Subject: Proposal for Enhanced signalling to be included in SPI-4

At the 4/27/2000 SPI-4 working group meeting, T10/99-295r4 was voted into SPI-4 with modifications agreed to in the meeting. The modifications were a combination of changes by unanimous consent and a few specific motions that were not unanimous but decisive.

Fast-160 Proposal

Figure 42 - Illustration of the driver precompensation technique.

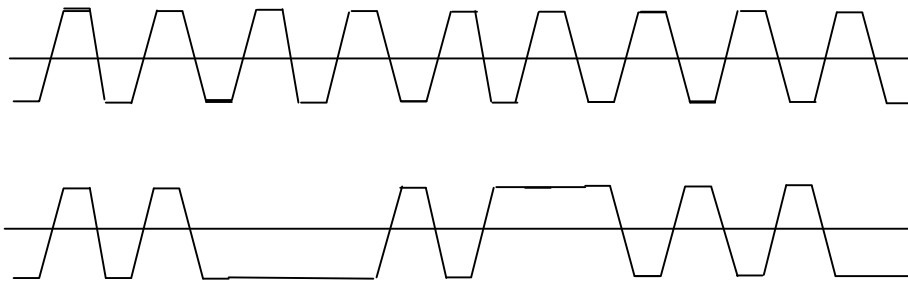
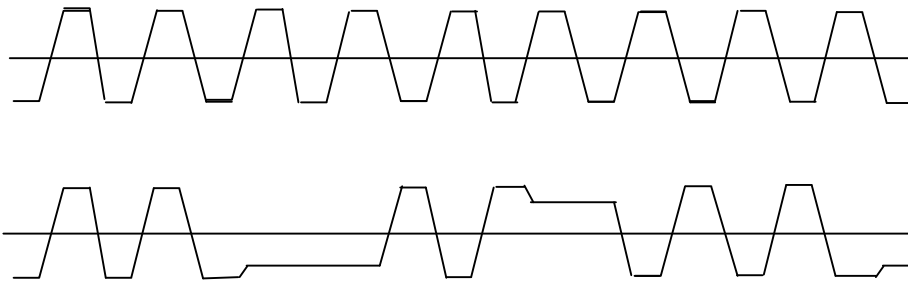
The LVD driver shall provide balanced asymmetrical sources that provide current from positive supply voltage to one signal line while sinking the same current to ground from the other signal line as shown in figure 42. Diagonally opposite sources operate together to produce a signal assertion or a signal negation. An assertion is produced when positive supply voltage current is sourced from SOURCE 4 to the +SIGNAL line and SOURCE 2 sinks the same current from the -SIGNAL line to ground. A negation is produced when positive supply voltage current is sourced from SOURCE 1 to the -SIGNAL line and SOURCE 3 sinks the same current from the +SIGNAL line to ground.

During data transfer phases, if the transfer mode is one with the PPR P EN (Precomp Enable) bit set to one, the driver source current shall comply with precompensation requirements in Table (New 1). Nominal driver current is sourced to or from the SCSI Data bus line for the first data transfer time after a change in the data bus line state from asserted to negated or from negated to asserted. After a data transfer time from the last data bus line state change the current sourced to or from the SCSI Data bus line shall be cutback (reduced) (see A.2.1). The rules for precompensation shall apply to REQ, ACK, P1, P CRCA as well as DB(15-0).

Figure TBD illustrates the transmitter drive strength technique.

Figure 45 - LVD timing measurement points for DT = Fast - 160 data transfers

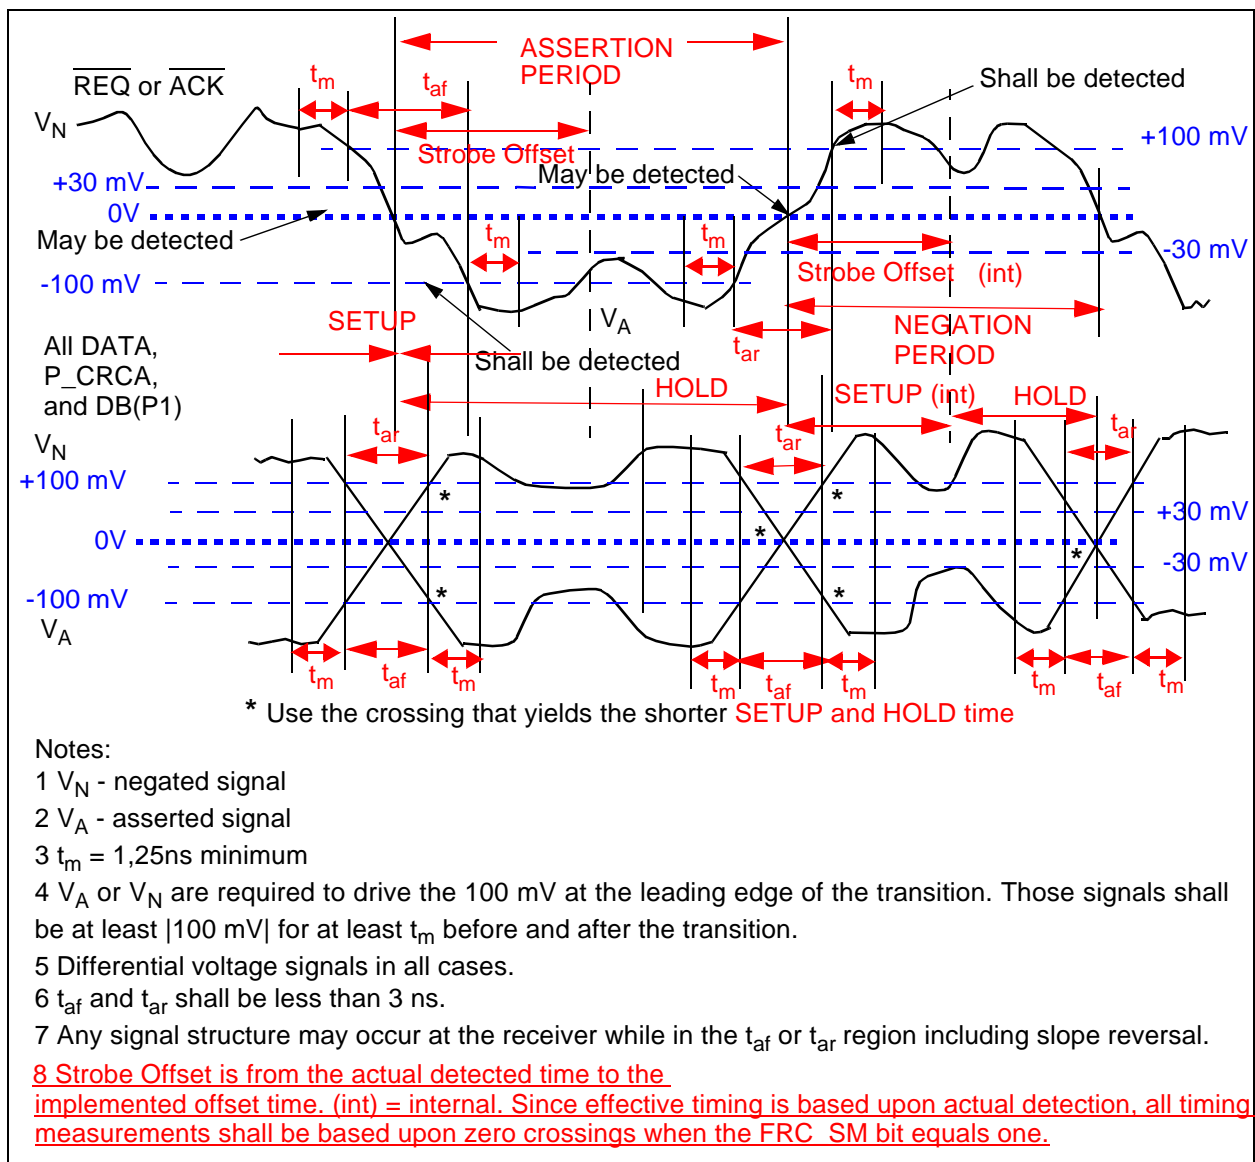
The signal shall transition from -100 to +100 mV or +100 to - 100 mV in 0 to 3 ns, the waveform between -100 and +100 mV is not otherwise specified. Signals shall remain above the |100 mV| level for 1,25 ns at each end of the transition. The signals shall not drop below |30 mV| except during the transitions. Conditions exist with longer, loaded SCSI busses and irregular REQ and ACK pulse widths where long assertions or negations produce a much larger signal than short assertions or negations. This sets up an environment where the short REQ or ACK pulses may not have adequate timing margin unless the definitions in figure 44 are used in the measurement of timing parameters. If the P_EN bit equals one precompensation mitigates the charging effect and helps timing margin.

Figure 46 - LVD receiver mask =< **Fast 80**

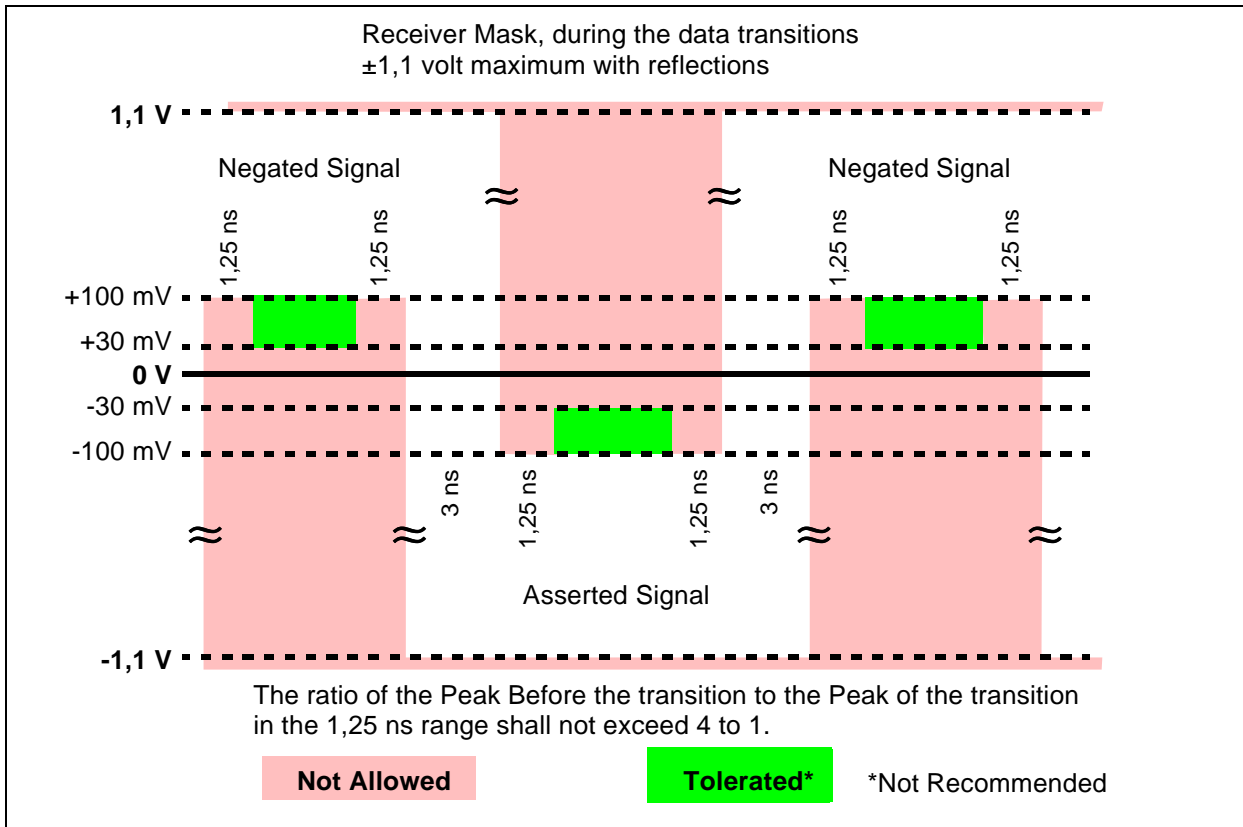
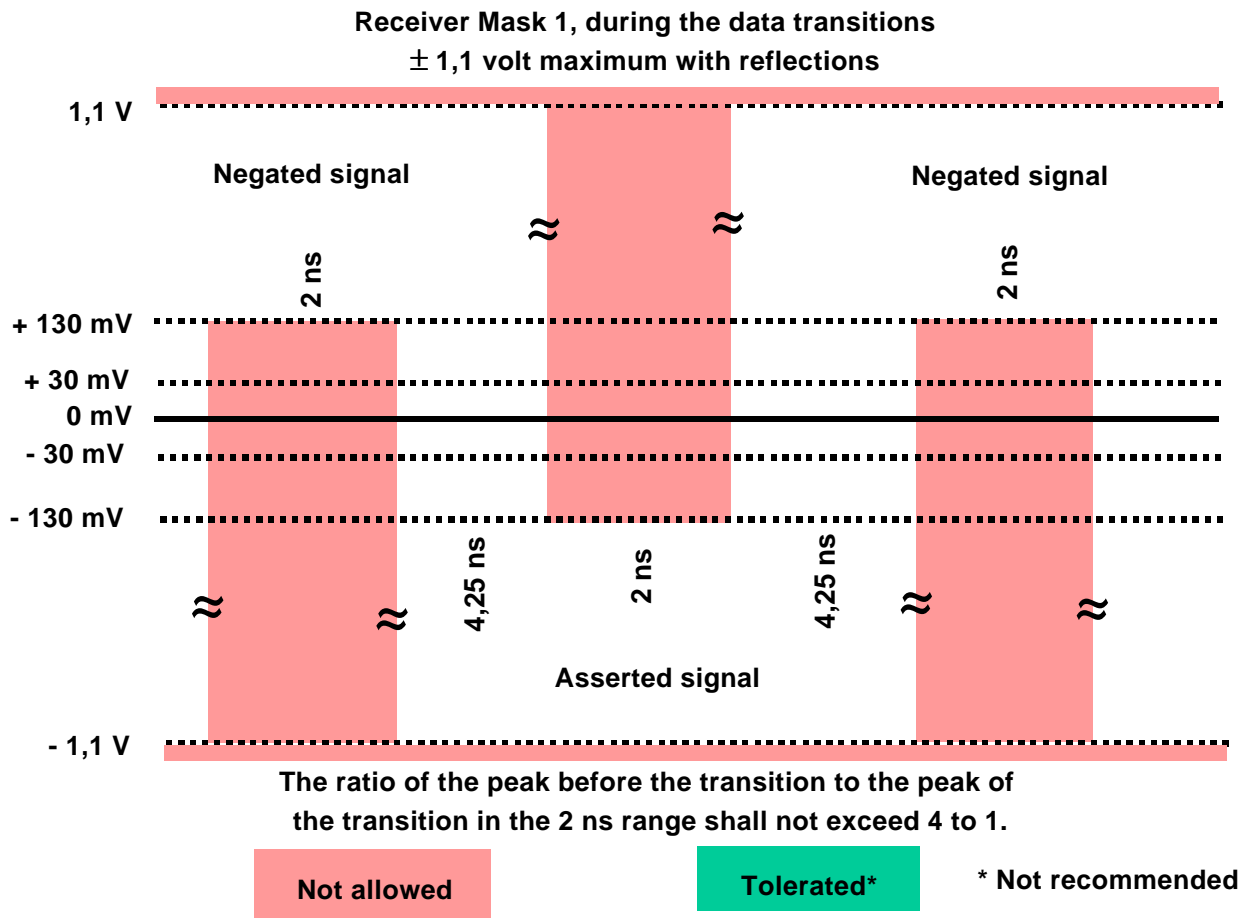
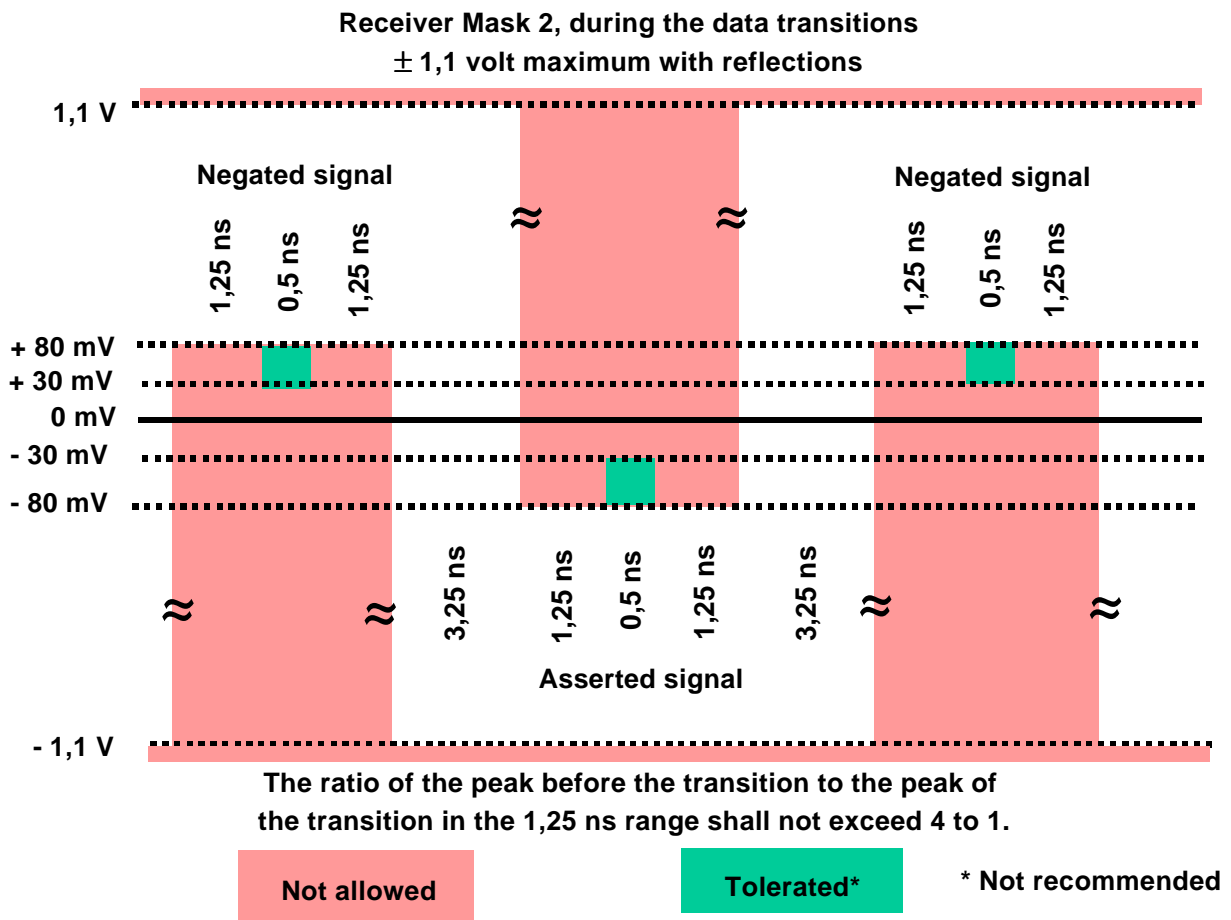
Figure TBD (46) shows the LVD signal requirements at the receiving SCSI device for Fast =<80. SCSI devices, during Fast - 160, shall operate with signals at the receiving SCSI device meeting either Figure TBD (47), Figure (48) or both. Mask 1 is applicable to signals that have more timing margin than those for Mask 2 and allows less amplitude margin than does Mask 2. The lower amplitude margin of Mask 1 may result in timing margin loss internal to the receiver. The higher amplitude margin of Mask 2 should result in less timing margin loss internal to the receiver.

Figure 50 - P1 Offset Control (Data Pacing)

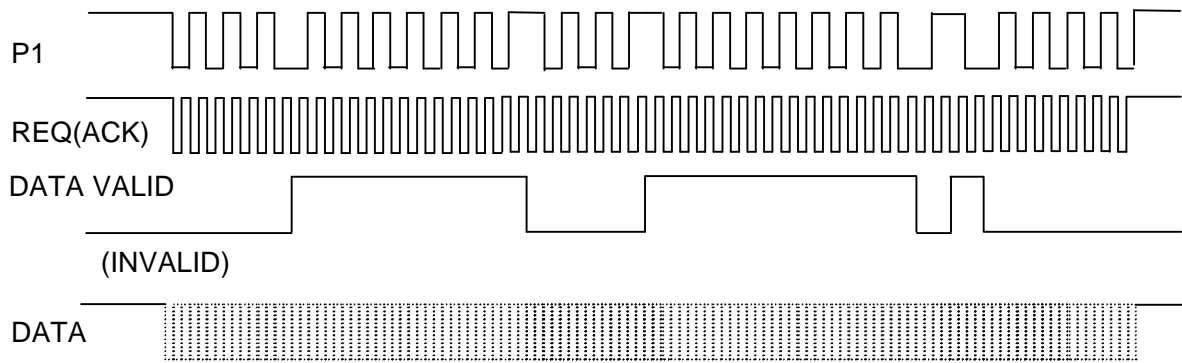
At the end of the training pattern or near the start of a data phase without a training pattern, a valid data state may begin. The sending device shall indicate the valid data state by reversing the phase of the P1 signal coincident with a REQ(ACK) assertion (i.e., by withholding the next transition of P1 at the start of the first two transfer periods of valid data). Beginning with the third valid data word, P1 shall be toggled every two transfer periods, coincident with a REQ(ACK) assertion during valid data. The minimum duration of the data valid state is two transfer periods, and the data valid state shall last an even number of transfer periods.

Figure (new) illustrates an initial clock start-up period and start of valid data for a data phase.

If the sending device pauses the sending of data, it shall again reverse the phase of P1 by withholding P1 transitions at the start of the first two transfer periods that do not have valid data. Beginning with the third transfer period without valid data, P1 shall be toggled every two transfer periods until valid data is sent. The data invalid state shall have at least one transition of P1 before changing states. The minimum data invalid time is four data transfer periods. This ensures a maximum run length of three cycles for P1. The data invalid state shall last an even number of transfer periods.

Figure 51 - Data In Training Pattern

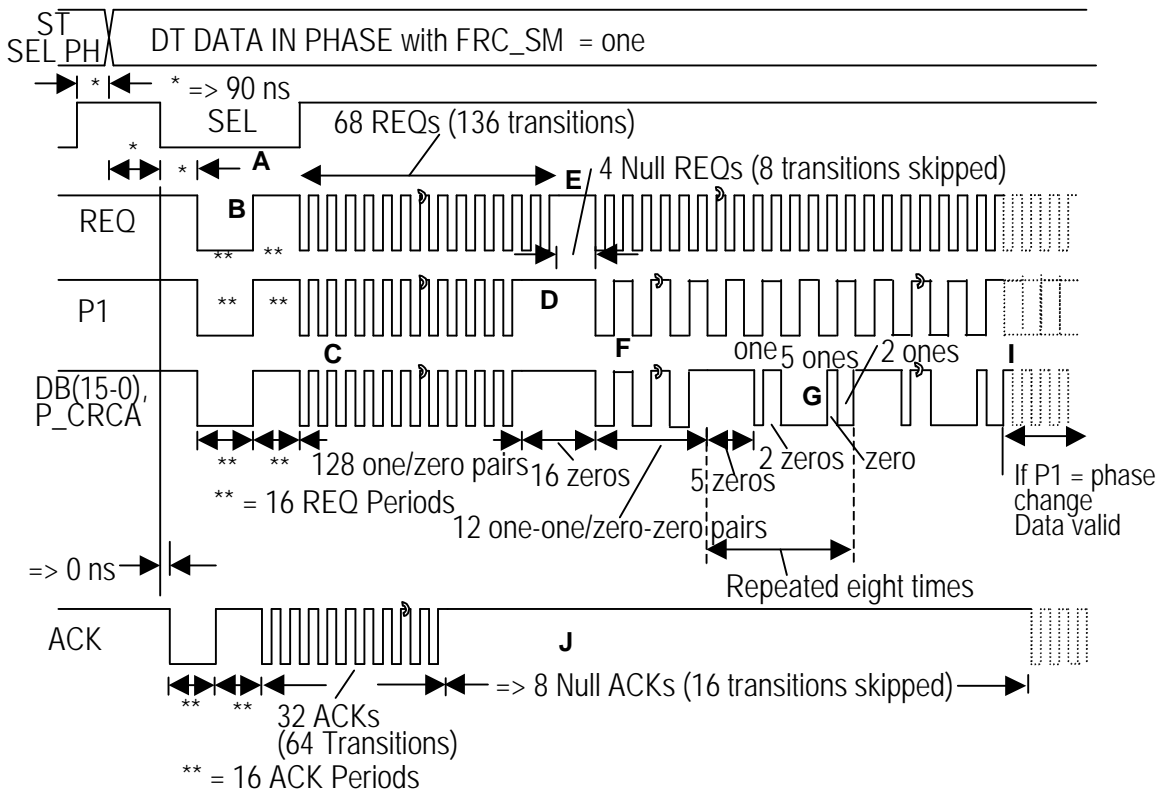
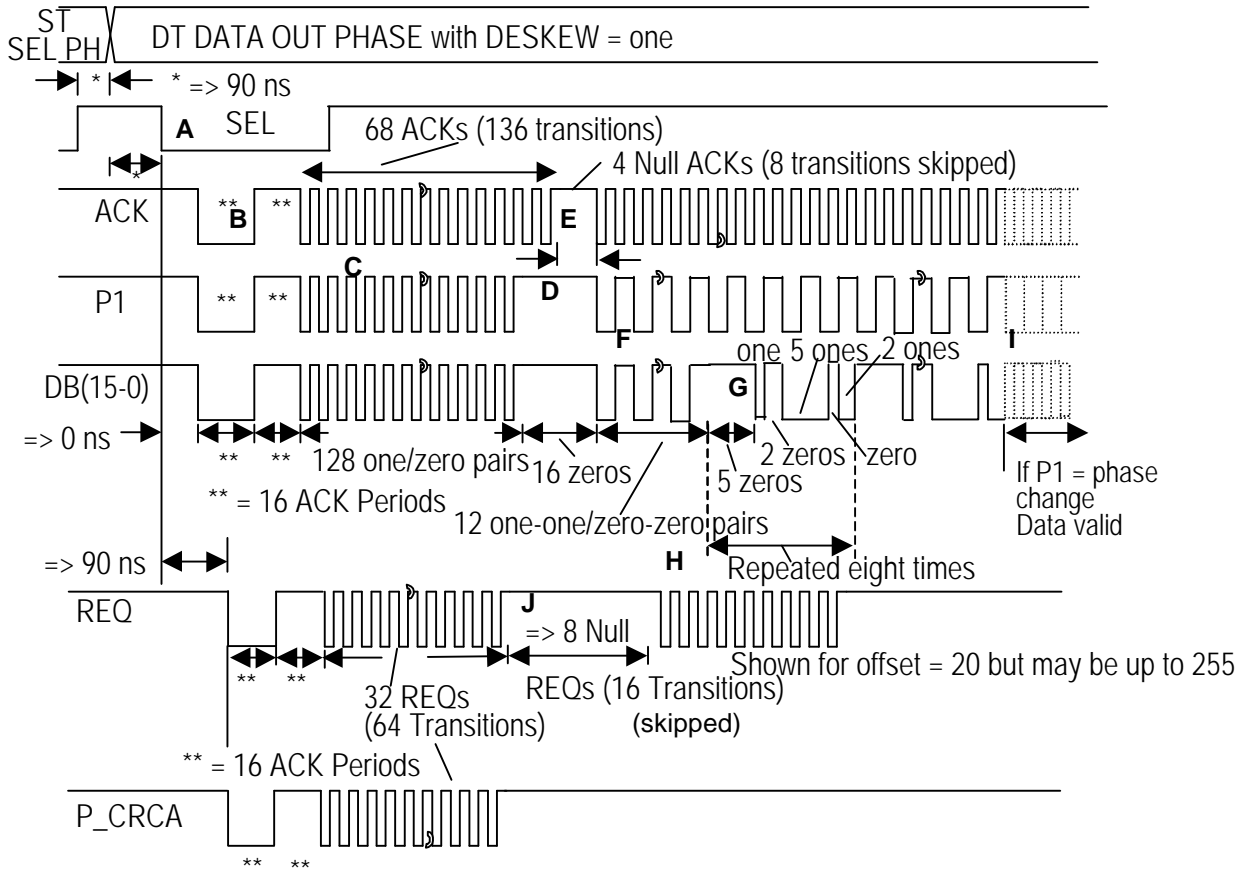
The training pattern shall be transferred at the start of the first data phase for each data transfer direction of an IT-Nexus when the FRC SM bit equals one. The training pattern shall not be transferred again after the start of the first data phase for each data transfer direction of an IT-Nexus and shall not be transferred at all when the FRC SM bit equals zero. The training pattern for Data In shall conform to Figure TBD. The training pattern for Data Out shall conform to Figure TBD. The receiving SCSI device shall use some or all elements of the training pattern to achieve deskewing. The transmitting device shall not make an intentional shift in relative timing between the databus and the REQ(ACK) signal subsequent to the training pattern during the DT data phase. The requirement to not intentionally change relative timing does not

The training pattern elements are shown in Table (new n).

Figure A.2 - Domain for driver assertion and negation levels

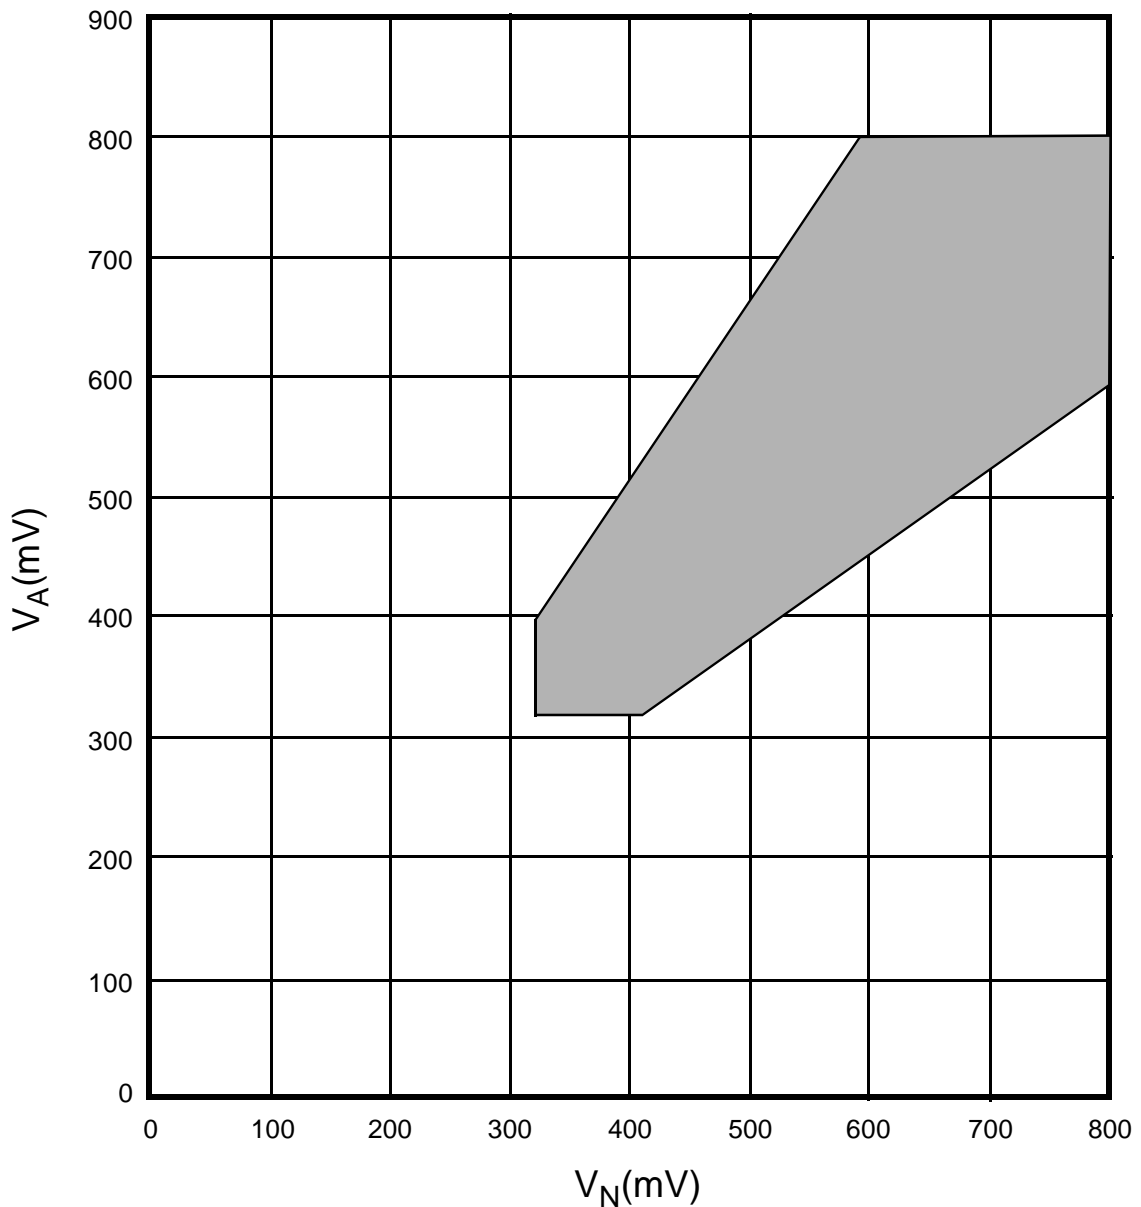
Editor's Note: Additional Fast-160 analysis needs to be done regarding the limits of Figure A.2 and receiver analysis.
